PACKARD DIVISION

counselor

VOL. 30, NO. 3

MARCH, 1956

Ignition Cable Support Brackets

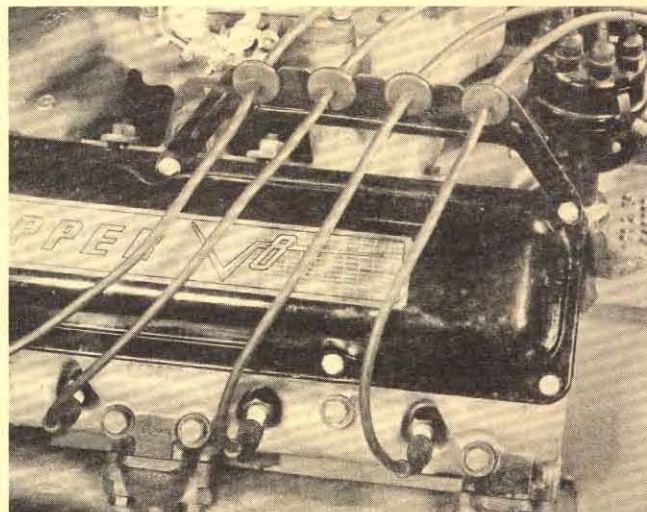
Cross-firing may be caused by pinched ignition cable wires between fingers of the cable supports breaking the wire insulation, separation of the dipped rubber from the cable supports or wires running parallel too close to one another for enough distance to permit capacitive coupling.

Should cross-firing occur, examine the ignition cables for broken insulation and if found satisfactory, install new ignition cable supports as shown in the illustration. The new supports spread the cables farther apart and the rubber grommets hold the cables at a greater distance from the metal supports.

1. Lift the ignition cables from between the support fingers on all four supports, remove and discard the cylinder head supports and the supports under the coil.

2. Install the new supports as shown in the illustration by attaching the supports under the center and rear cap screws for the rocker cover. Only one support is used per side.
3. Install the grommets on the cables and position the grommets in the supports leaving the cables at the approximate length shown.
4. It will be necessary to cut off some of the cables to obtain proper length between the support and the distributor cap. Remove the cables one at a time from the distributor cap, remove the cable terminals and cut off the amount of cable as listed and reinstall the terminal and cable in the cap.

Fig. 1

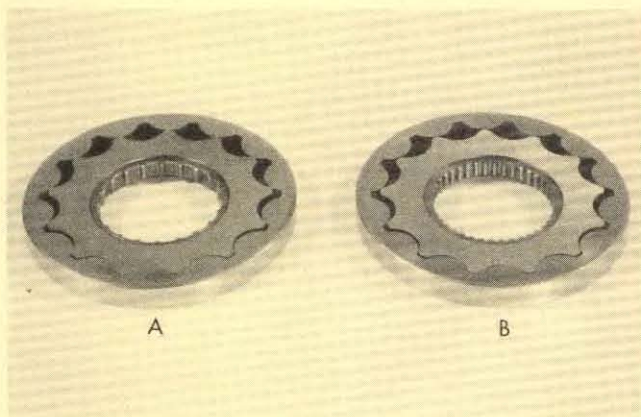
"A" figure 1, shows the front oil pump rotor having 20 internal splines that is used in 54th Series Gear-Start, 55th and early 56th Series Ultramatic transmissions.

56th Series transmissions starting with serial numbers A-9681, B-6012, C-1143, D-1862 have front oil pumps with the direct clutch passage in the rear and also have the rotors with 40 tooth splines on the internal driving section, "B" figure 1.

New rotors with 40 splines and front pump assemblies with 40 spline rotors have been released for service replacement and are listed for your ready reference.

Fig. 2

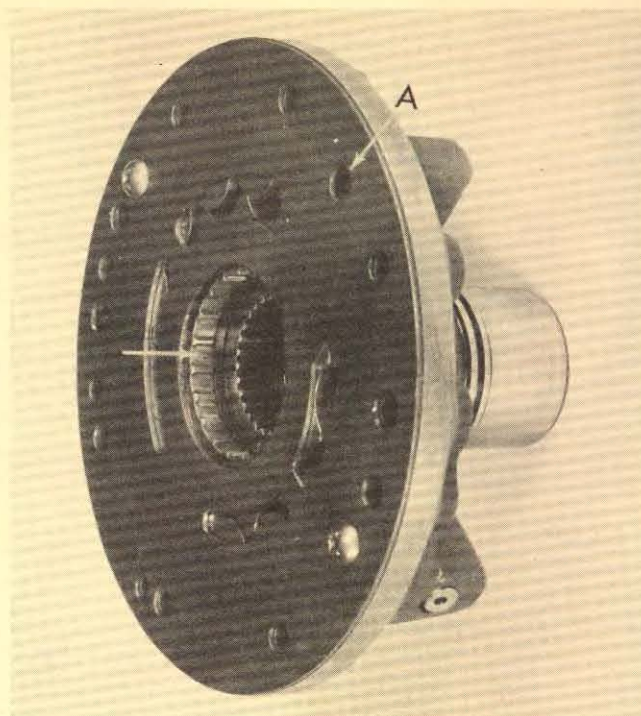
On 54th Series Gear-Start, all 55th and 56th Series Ultramatic transmissions up to transmission serial number A-6481, B-4741, C-1057, oil pressure for the direct drive clutch came out of a passage on the front side of the pump. See "A" figure 2. The oil pressure is directed through a passage in the bell housing, then past the open splines in the rotor to the input shaft.

Fig. 3

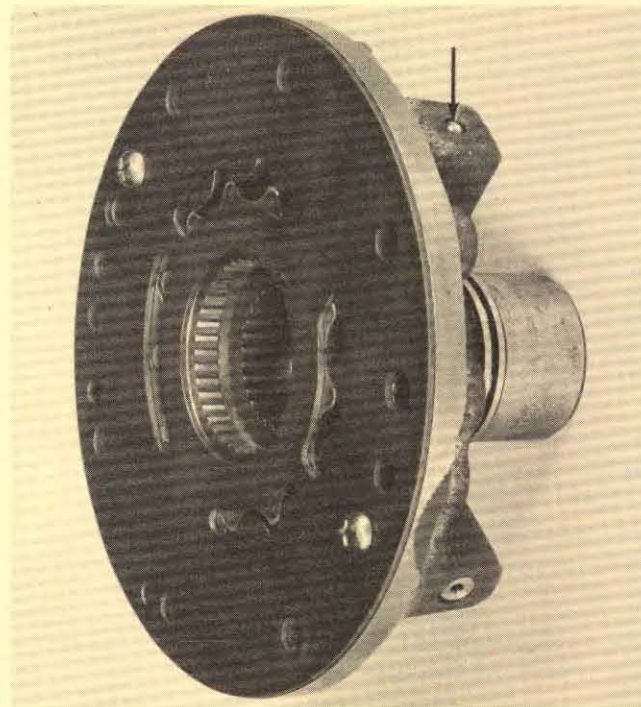
56th Series transmissions after the above serial numbers have front oil pumps with the direct clutch oil passage in the rear side of the pump. "See arrow figure 3," also note the oil passage hole is not in the front plate. However, *these pumps have the 20 tooth*

splined rotors. (40 tooth rotor is shown in the illustration.)

Fig. 4

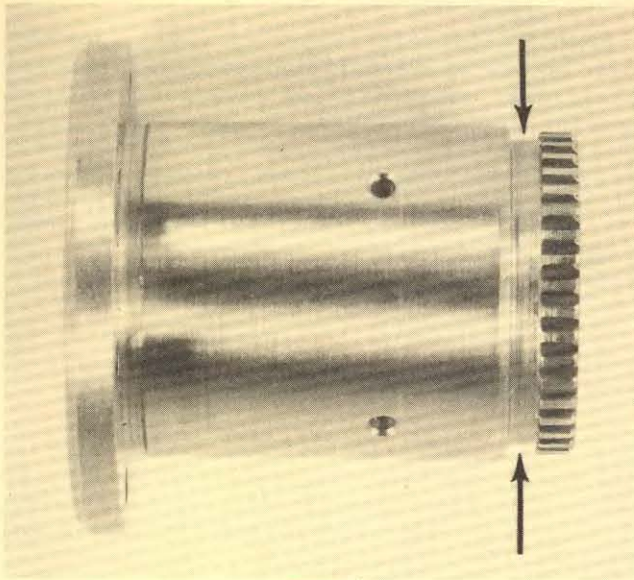
The pump assembly listed above has the oil passage in the front side of the body and the rotor has 40 splines, therefore it will be necessary to drill six $\frac{1}{8}$ " holes through the annular groove just back of the splines in the converter shaft to provide an oil passage to the direct drive clutch. "See arrows figure 4." This also applies when replacing the rotor assembly. Be sure to remove burrs from edges of $\frac{1}{8}$ " holes and internal bushing after drilling.

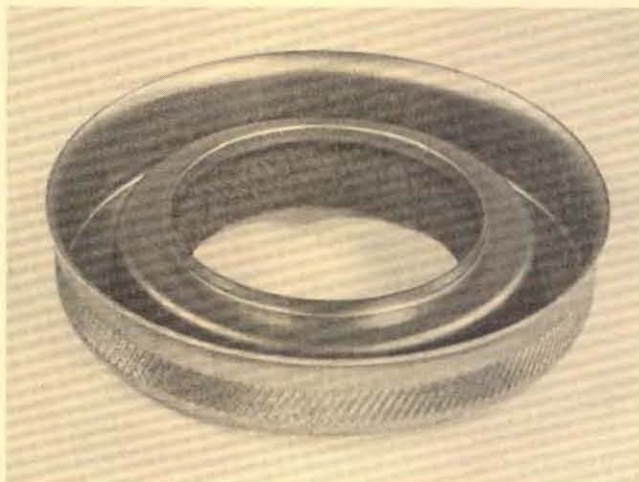
Production is now using a seal with the outer diameter of the retainer knurled to prevent the seal from turning. "See illustration."

The new seal with the knurled retainer will press tightly into the cover even in cases where an old seal has turned.

The new seal assembly can be ordered under Part No. 6489724.
